Service Information

Fig. 1

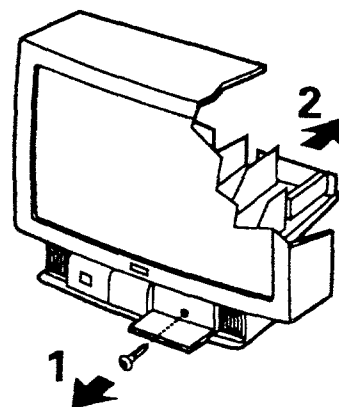
During production, as from week 9147, the control panel has been fixed with a screw from the front side of the cabinet (see Fig.1). This means that this screw must first be removed before the chassis can be pulled back and set in the service position.

Code numbers without screw hole:

ornamental plate 4822 454 12753

holder for keyboard 4822 256 91809

keyboard 4822 218 20986

Code numbers with screw hole:

ornamental plate 4822 454 12811

holder for keyboard 4822 256 91877

keyboard 4822 218 21075
